## Declaration of changes from V2247 to V2322

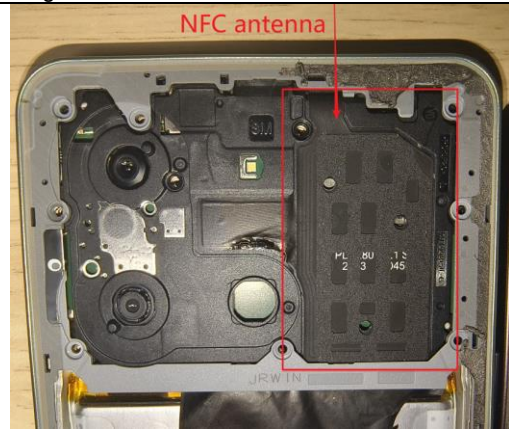
- Platform changes: No,
- PCB Layout changes: No
- Band changes: No
- Battery change: No
- **Charger change: Yes, add new charger (V4440L0A0-US)**
